**Report of the Committee on
Agricultural Dusts**

This Report was prepared by the **Technical Committee on Agricultural Dusts** and proposes for adoption amendments to NFPA 61-1995, **Standard for the Prevention of Fires and Dust Explosions in Agricultural and Food Products Facilities**. NFPA 61-1995 is published in Volume 3 of the 1998 National Fire Codes and in separate pamphlet form.

NFPA 61 — A99 ROP

Figure 5-4(a) Typical elevator explosion venting.

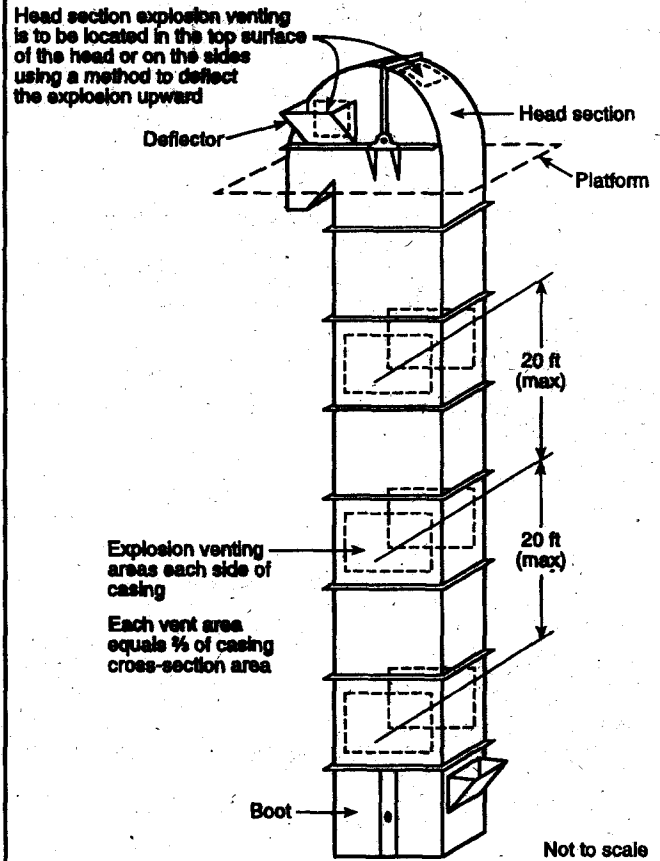
61-14 - (Figure 5-4(a) and (b) (new) and 5-4.1.2 and 5-4.2.2):

RECOMMENDATION: Add the two figures as Figures 5-4(a) and 5-4(b) as follows:

Accordingly, modify text of existing Sections 5-4.1.2 and 5-4.2.2 to include the text (at the end of the existing text) to read as follows: Figures 5-4(a) and (b) illustrate two typical elevator explosion venting designs.

SUBSTANTIATION: The figures were added to provide additional clarification of the requirements of existing Section 5-4. **COMMITTEE ACTION:** Accept.
